Access Compliance Report Public Rights-of-Way (Curb Ramps)

Main Street: CROWN_VALLEY_PKWY		Cross Street: CROWN_VALLEY_PKWY		Location:	NE
ADA ID: RPRK211026120136	Ramp Type: Type 4 - Parallel	Initial Pass/Fail: Fail	Overall Compliance: No	Severity Score:	30

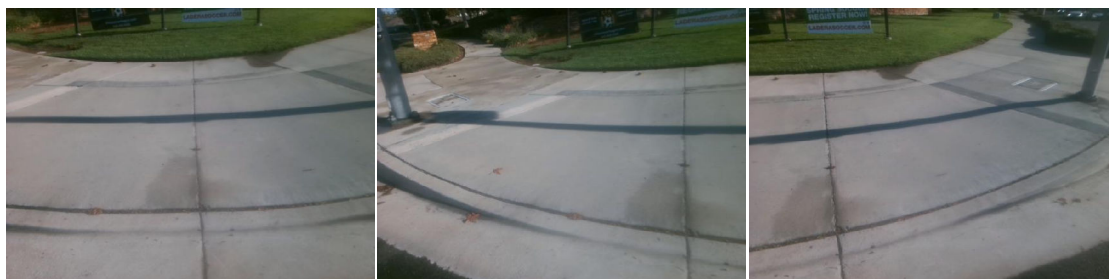
R204.3, R304.5.3, STD 1115

Remove & Replace Curb Ramp With Two New Directional Ramps or Equivalent.
